COMMUNITY DEVELOPMENT DEPARTMENT REPORT

SUBJECT: H-2024-0043
Newkirk East MDA, PP

A Preliminary Plat and Development Agreement Modification to convert 216 apartments into 95 single-family attached homes on 10.08 acres of land zoned Traditional Neighborhood Residential (TN-R).

E. Landscape Plan (date: 7/3/2024)

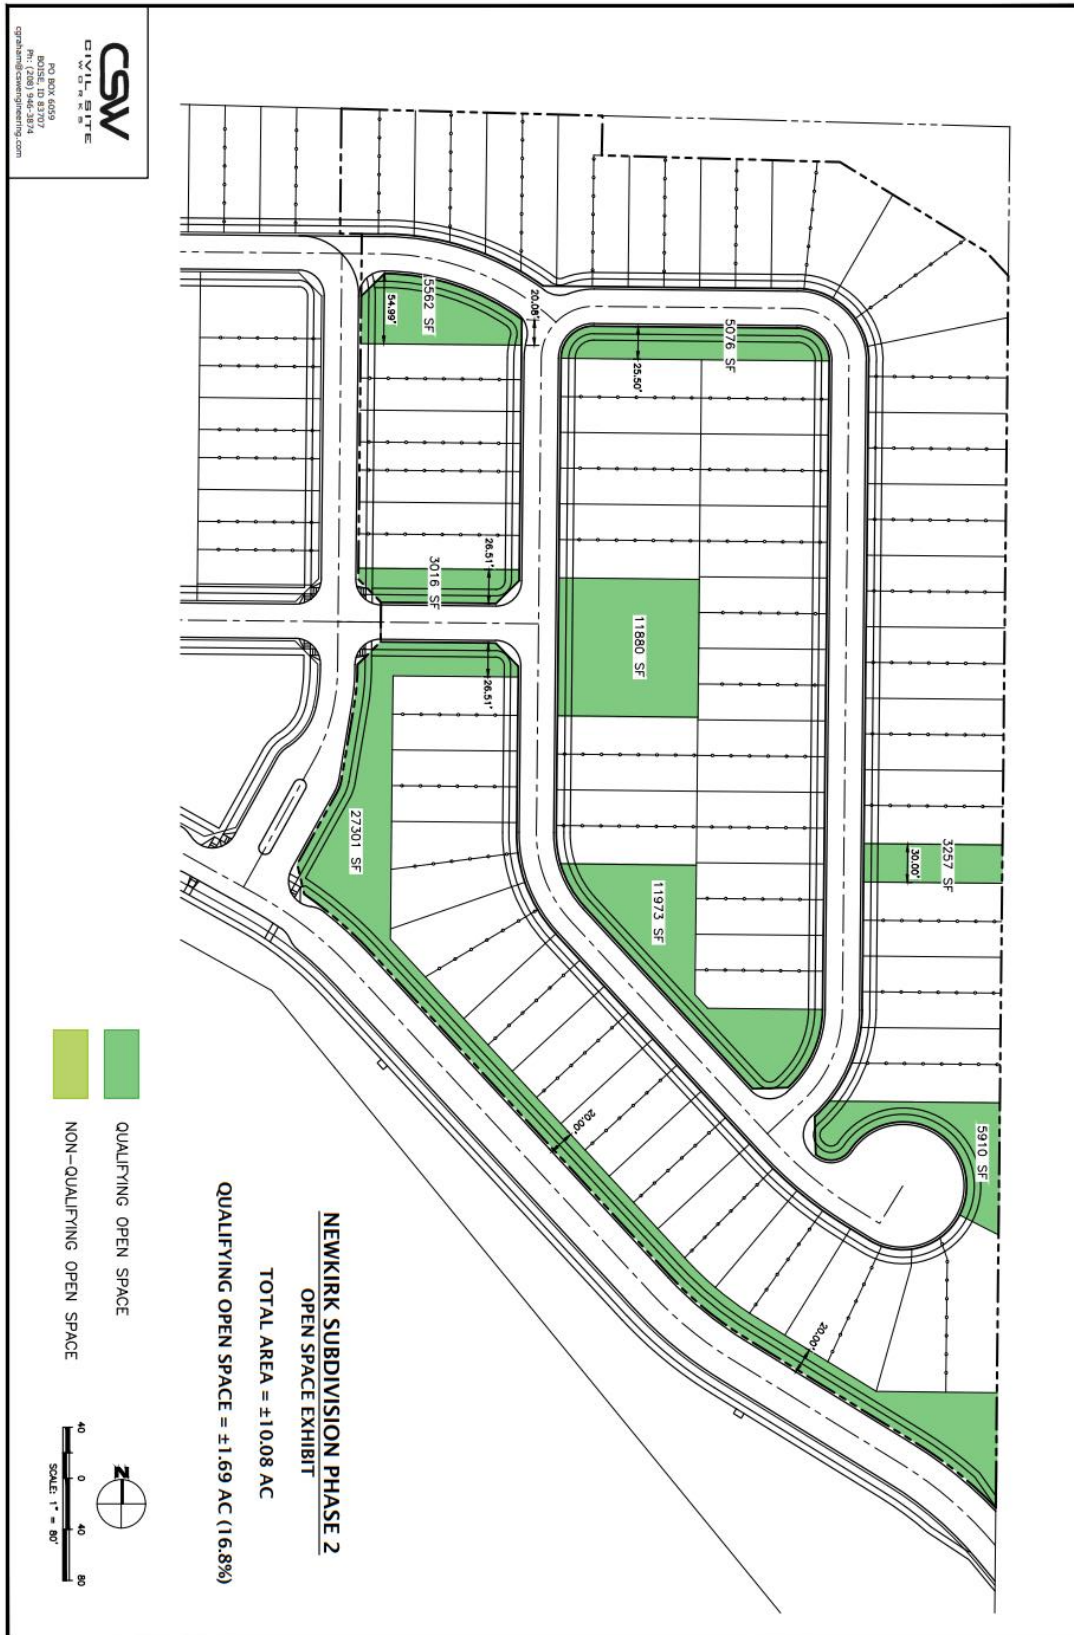
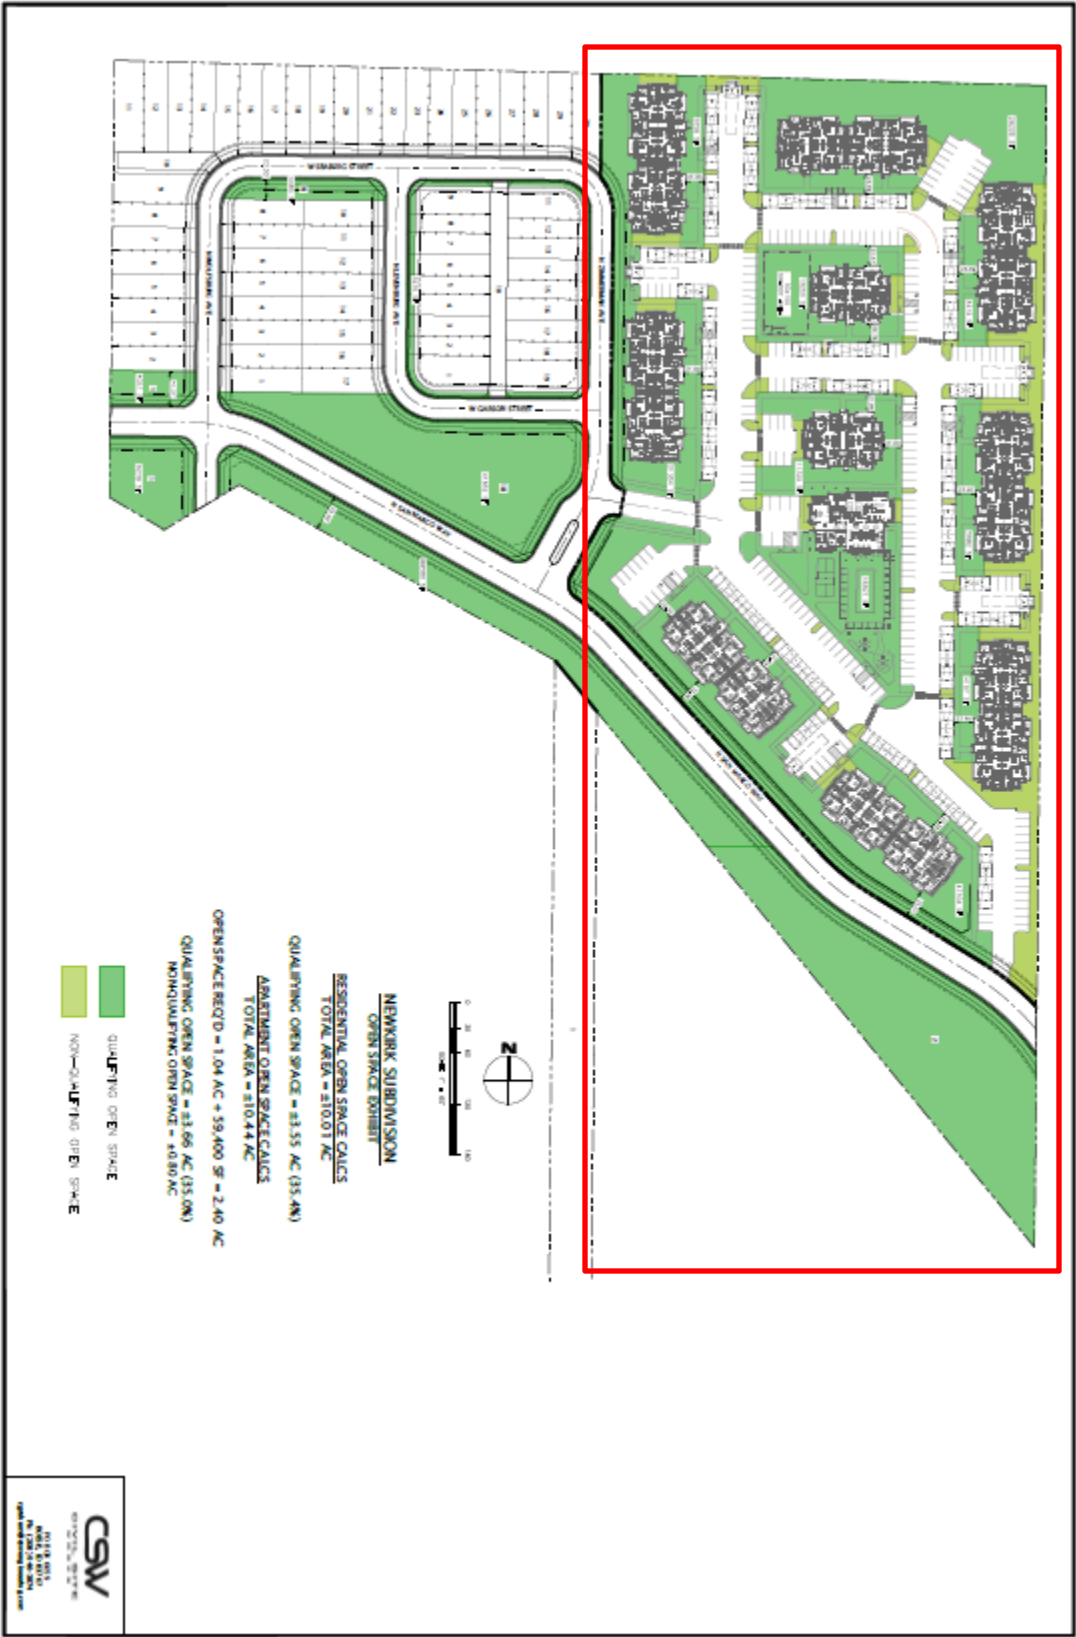
7. Parkways (Comp Plan 3.07.01C, UDC 11-3A-17):
Per Comp Plan policy 3.07.01C appropriate landscaping, buffers, and noise mitigation with new development along transportation corridors (setback, vegetation, low walls, berms, etc.) is required.
Per the UDC the minimum width of parkways planted with Class II trees shall be eight (8) feet. The width can be measured from the back of curb where there is no likely expansion of the street section within the right-of-way; the parkway width shall exclude the width of the sidewalk. Class II trees are the preferred parkway trees. The applicant will be required to revise their landscape plan to show Class II trees.

- g. Depict an 8-foot wide parkway with Class II trees along all local streets per UDC [Table 11-2D-6](#), landscaped per the standards listed in UDC [11-3B-7C](#). Include the linear feet of parkways with the number of required vs. provided trees in the Landscape Calculations table that demonstrates compliance with UDC standards.

I. Block Length Exhibit (date: 7/3/2024)

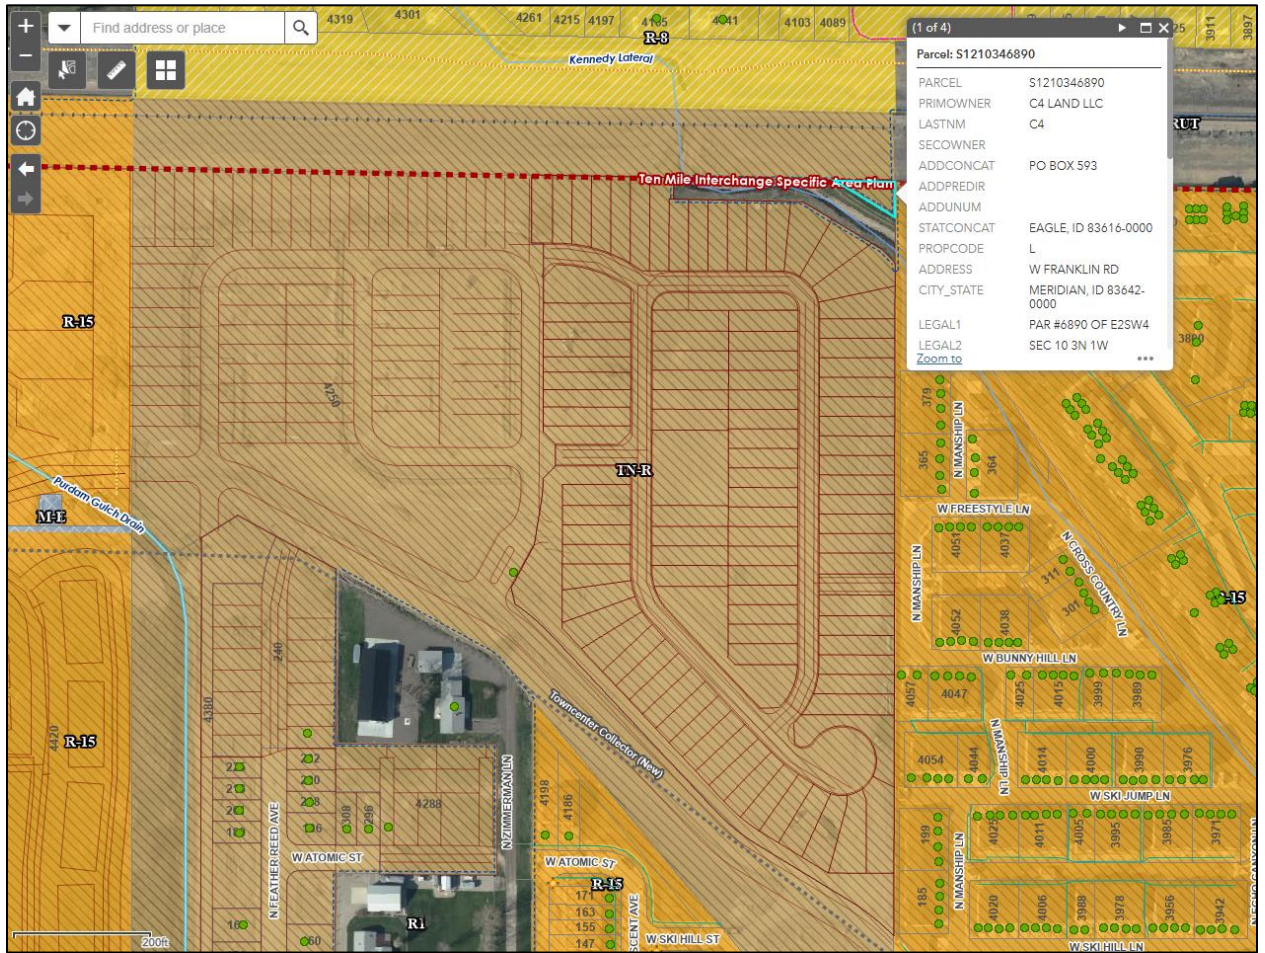
UDC 11-6C-3- regulates block lengths for residential subdivisions. Staff has reviewed the submitted plat for conformance with these regulations. In the TN-C and TN-R districts, no block face shall be more than five hundred (500) feet in length without an intersecting street or alley, except as allowed in subsection (F)(3). Subsection (F)(3) states where a pedestrian connection is provided, the maximum block face may be extended up to seven hundred fifty (750) feet in length in the TN-R District.

The applicant has several blocks lengths that exceed the 500 feet which need to be shorten or justification needs to be provided as to why they cannot meet the requirement. The applicant has provided an emergency access to N. Manship Lane within the Entrata Farms Subdivision No. 2, which counts towards a break in the block length on the east side of the roadway. The applicant can provide access to the open space area along N. Ascent Avenue from N. Wolfsburg Avenue to break up the block length on the west side of the road. Revise the plat map to bring the block length along A. Wolfsburg Avenue into compliance by adding a pedestrian facility along Block 3, in the vicinity of lots 20-23 to connect to the common lot on Lot 3, Block 3.

- **Revise the plat map to bring the block length along A. Wolfsburg Avenue into compliance by adding a pedestrian facility along Block 3, in the vicinity of lots 20-23 to connect to the common lot on Lot 3, Block 3.**
